## PLANNING COMMISSION STAFF REPORT

SUBJECT: RODNEY DREW, OWNER FOR A MINOR ARCHITECTURAL REVIEW OF A 672-SQUARE FOOT FREESTANDING CARPORT ON A HILLSIDE LOT LOCATED AT 985 VIA LIVORNO, ZONE R-1-B (CASE 3.3799 MAA) (GM)

- 
5. **RODNEY DREW, OWNER FOR A MINOR ARCHITECTURAL REVIEW OF A 648-SQUARE FOOT FREESTANDING CARPORT ON A HILLSIDE LOT LOCATED AT 985 VIA LIVORNO, ZONE R-1-B (CASE 3.3799 MAA). (GM)**

ROONEY DREW  
 985 VIA LIVORNO  
 PALM SPRINGS, CA.

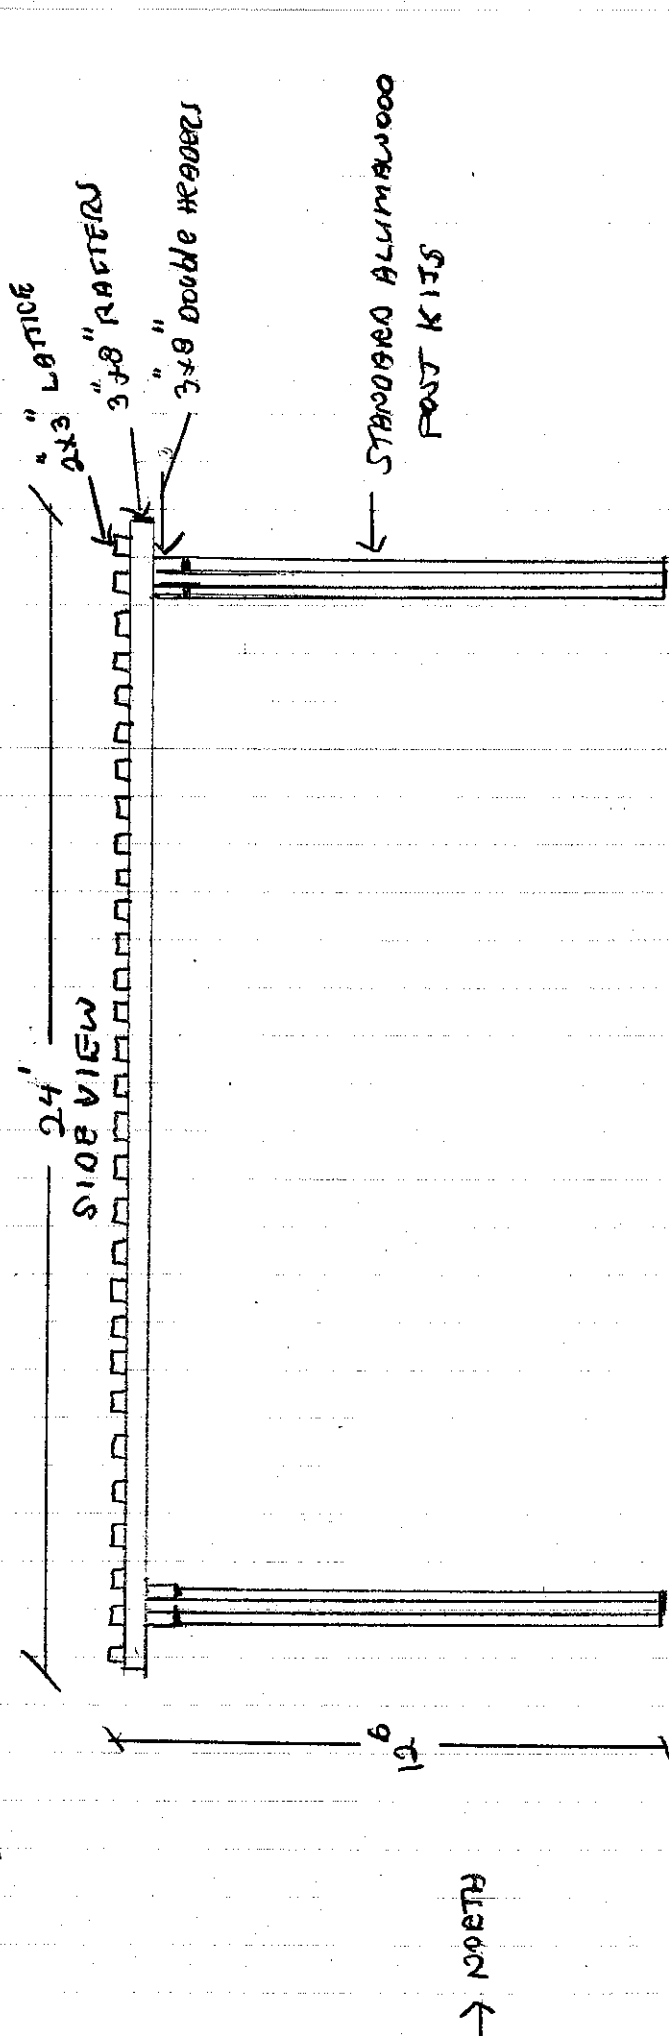
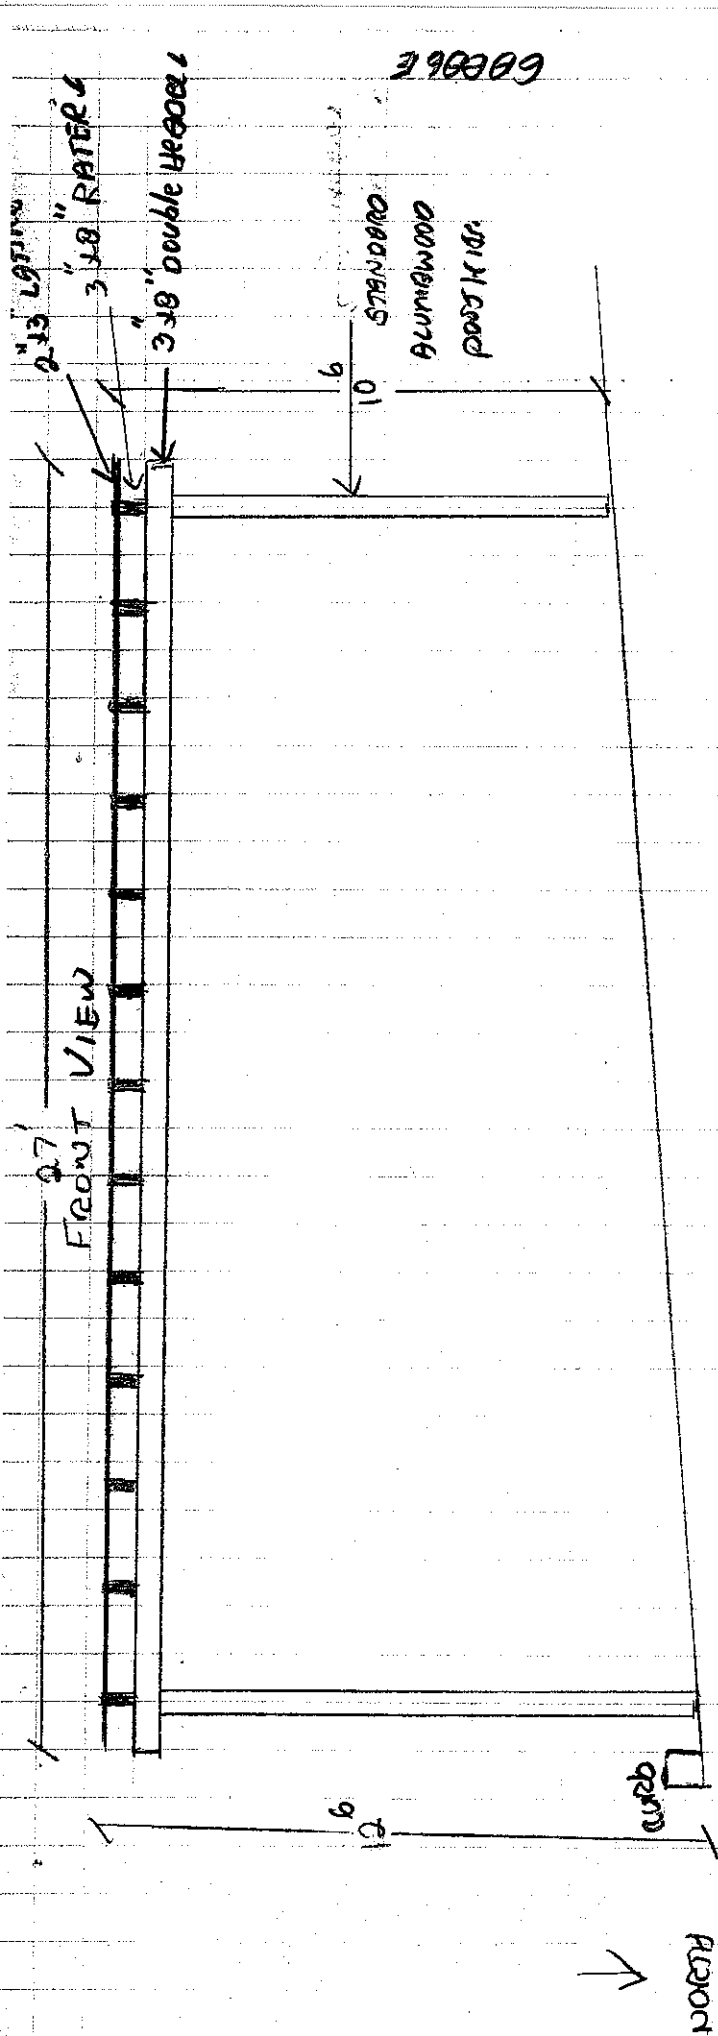
<i>Related Relevant City Actions by Planning, Fire, Building, etc.</i>	
10/3/1957	Building permit issued for construction of house.
12/22/2014	AAC reviews project and recommends approval to the Planning Commission with one condition: <ul style="list-style-type: none"> <li>• Submit revised site plan accurately showing location of support posts.</li> </ul>

The Architectural Advisory Committee (AAC) reviewed the project on December 22, 2014 and voted 7-0 to recommend approval to the Planning Commission with the submission of a revised site plan showing the location of posts accurately dimensioned on plans. The AAC was concerned about safety issues relating to backing-up and turning movements. The revised site plan has addressed this concern by widening the carport allowing the support posts to be placed at the existing planter walls.

Chair Fauber questioned the 14 foot distance between the garage and the carport; and if the lattice would be aluminum too.

Member Secoy-Jensen questioned if there would be adequate space for vehicles to maneuver under the carport.

Member Purnel asked if posts will be in planters or in front of the planter wall. He questioned how the design of the carport matches the design of the house - it is architecturally disconnected. He discussed the use of a valance to simulate details of the house.

- Indicate post locations on plans, and properly dimension all plan elements.

- PLN 1. Color of Alumawood carport to be light brown.
- PLN 2. Approval is to be pursuant to plans date stamped May 4, 2015.
- PLN 3. Architectural Advisory Committee recommended Conditions of Approval to include:
- Submit revised site plan accurately showing location of support posts.
- PLN 4. Notice to future buyers on views. All prospective buyers of 985 Via Livorno shall be put on notice that there are no written or implied rights to the preservation of scenic views from any lot.
- PLN 5. *(Conditions imposed by Planning Commission at meeting).*
